23 February 2024

Our ref: RL-01-2001-03

RE: Peer Review of the Flood Study for the 43-65 Cowper Street, Warrawong State-Assessed Planning Proposal (SAPP) Pilot Program

Figure 1 Lake Illawarra PMF Hazard and Extent

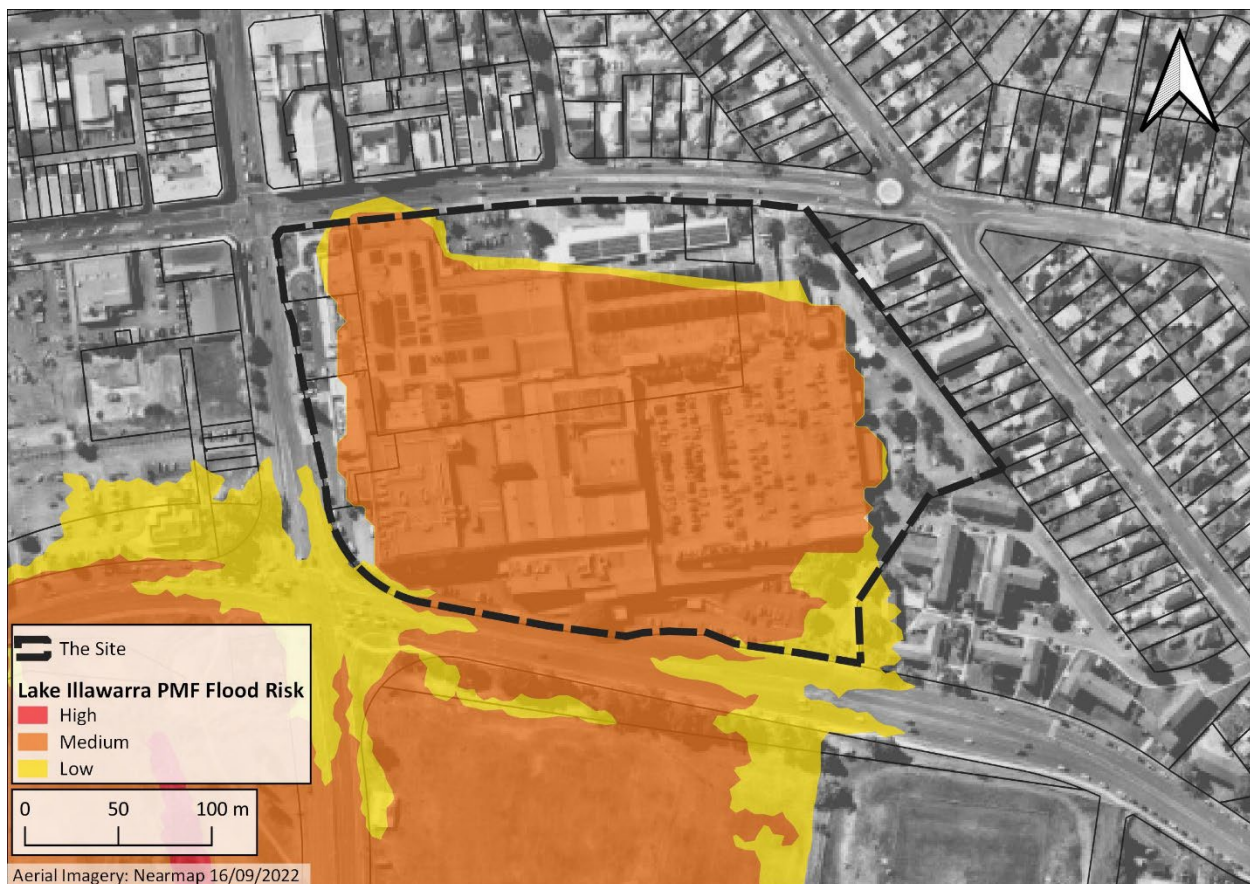
However, it is noted that the applicant has updated the Lake Illawarra floodplain extents using the available design flood level for the Lake using more recent and accurate topographic data showing that much less of the site is within the floodplain (refer figure 12 of the Warrawong Plaza Planning Proposal – Flood Assessment Report, dated 20 December 2023).

Figure 3 1% AEP flood depths at east of site, unknown building circled

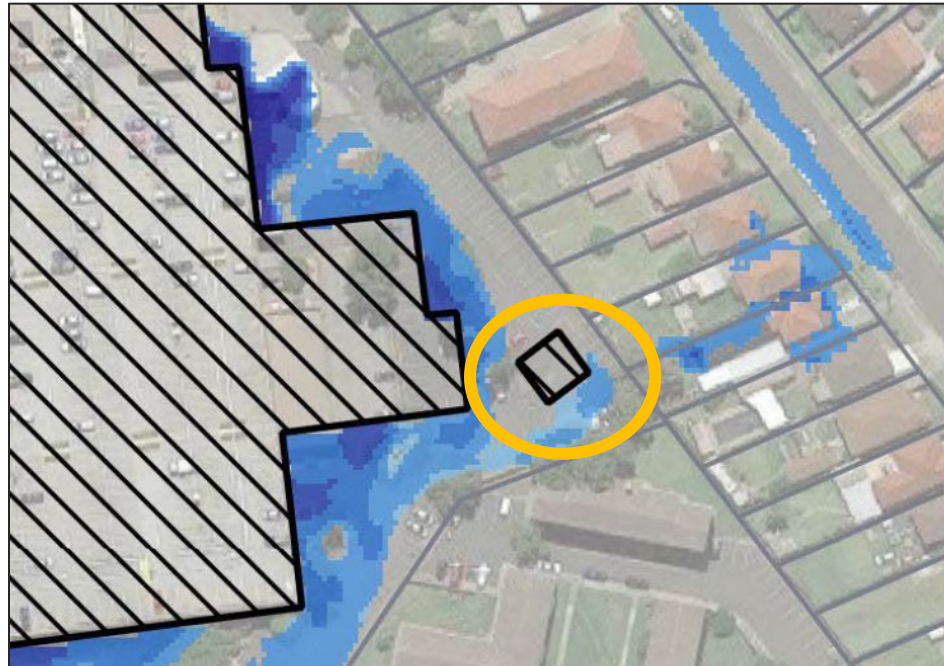
There is a structure that is blocked out of the model extent to the east of the site (see **Figure 3** in the reference design and the flood impact assessment should clarify the proposed use of this structure as it is surrounded by floodwaters in the 1% AEP and PMF events.

Figure 4 Third entrance to basement carpark (drawing number left: A-SK-029 rev. F, right: A-SK-006 rev. F)

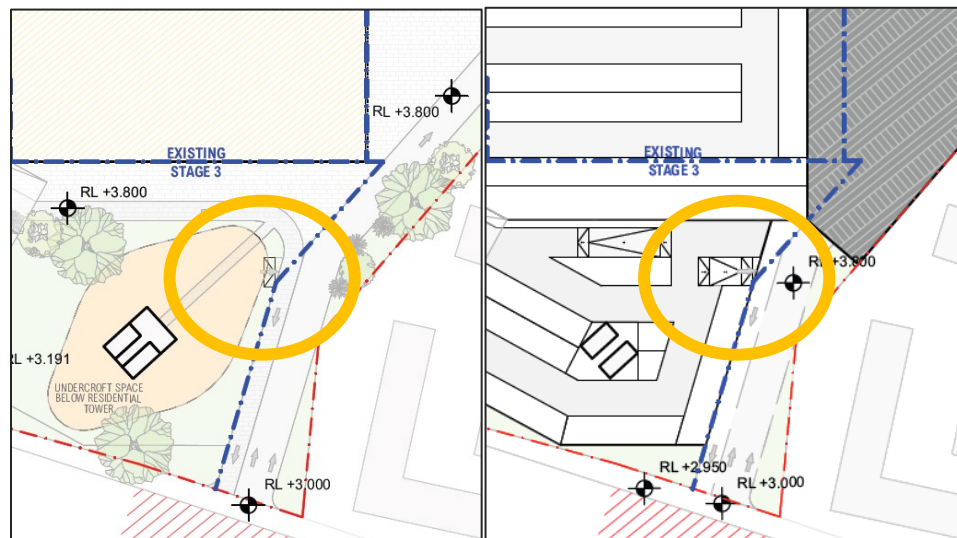
It is understood that there are entrances to the underground carpark on Cowper Street and on Northcliffe Drive as these are mentioned throughout the planning proposal attachments. In the Reference Design there also appears to be an entrance underneath Building G (see **Figure 4**), opening to the pedestrian through-site link. The applicant should provide the proposed crest levels for this entrance and indicate if it is intended for vehicles only or for pedestrians. Furthermore, it appears that this entrance would be in, or very close to, the overland flow path through the south east of the site. The applicant should ensure that this entrance is suitably designed for the flood conditions on the site.

Figure 5 Post development 1% AEP flood depths (left) and flood hazard (right).

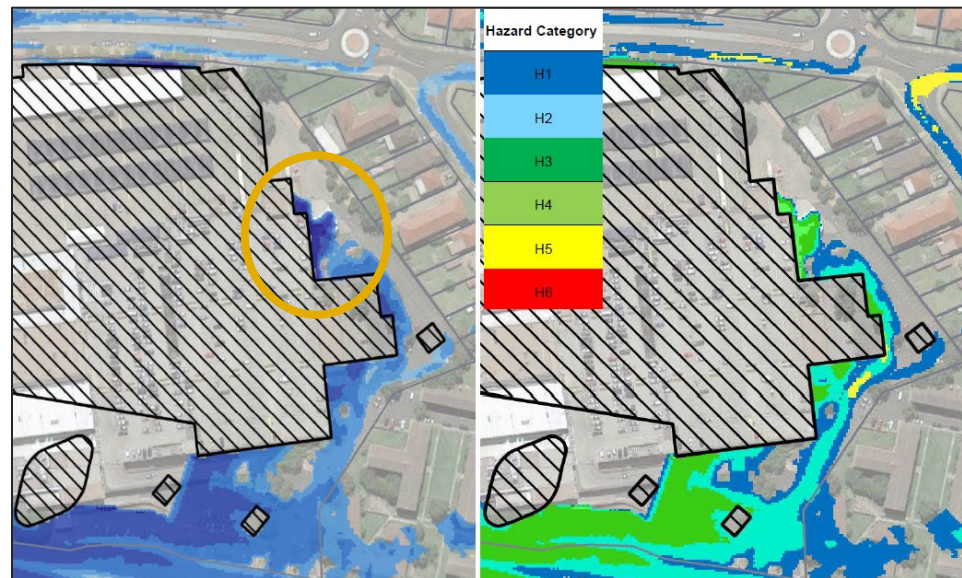
Flood Hazard	<p>Within the site boundary, the proposal results in increased maximum flood depths of approximately one metre in all events tested. In the 1% AEP flood event, the assessment states that the maximum depth at the site under the proposed conditions scenario reaches 2.75 m within the eastern carpark adjacent to the new Woolworths extension (circled in Figure 5). Depths of this magnitude would present a significant risk to life, and it is recommended that this be rectified in future design iterations.</p> <p>It is also recommended that the hydraulic hazard mapping be reviewed by the applicant as the locations where the deepest flooding occurs within the eastern carpark in the 1% AEP coincide with areas of H4 hazard (see Figure 5). Referring to figure 3-34 in the provided flood impact assessment, it is not possible to have depths of 2.75 m and a hazard category of anything lower than H5. There also appears to be inconsistencies between the existing flood hazard mapping presented in the flood impact assessment and in the Kully Bay Overland Flow Study (Rhelm, 2019), see Figure 6.</p>
